ADDENDUM NO. 17

April 29, 2019

**STUDENT SUCCESS CENTER
PROJECT NO. 950512**

EXTERIOR TRANSFORMER LOCATION EXHIBIT

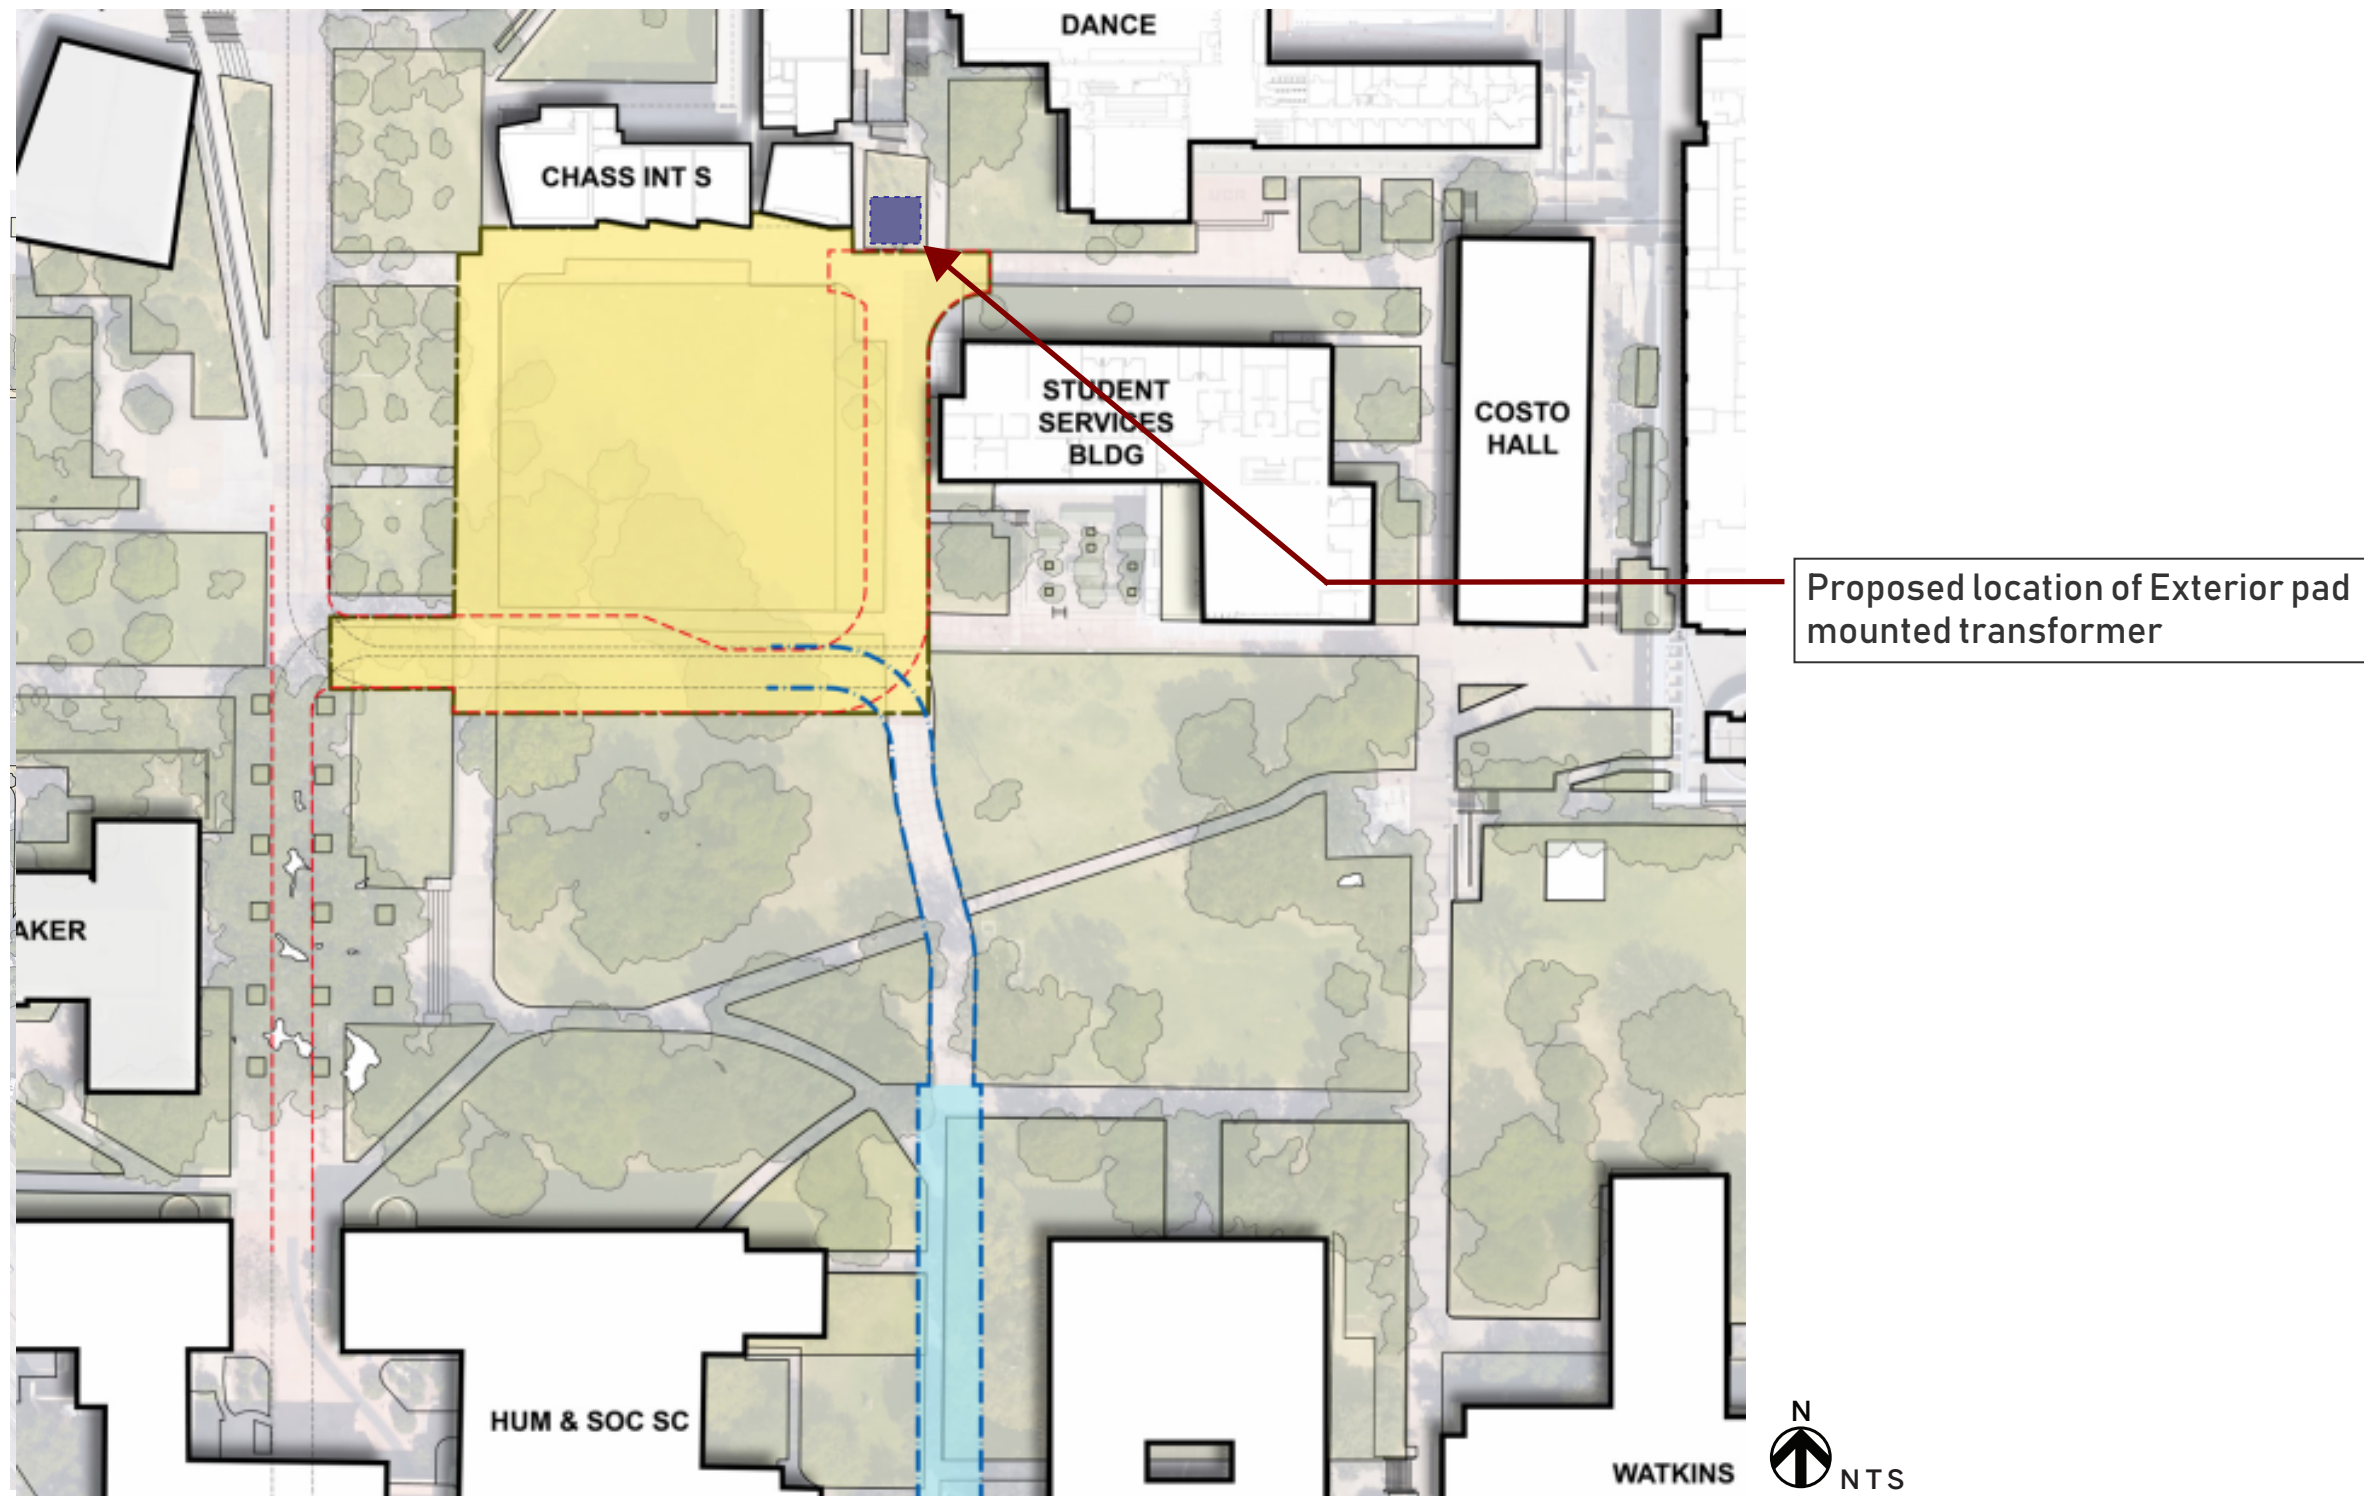
The University has identified the following preferred location for an exterior transformer.

1. **Add** “Transformer Location: Exterior Transformer Location Exhibit” pages 6.52 to the Table of Contents Section 6.0 Appendix.
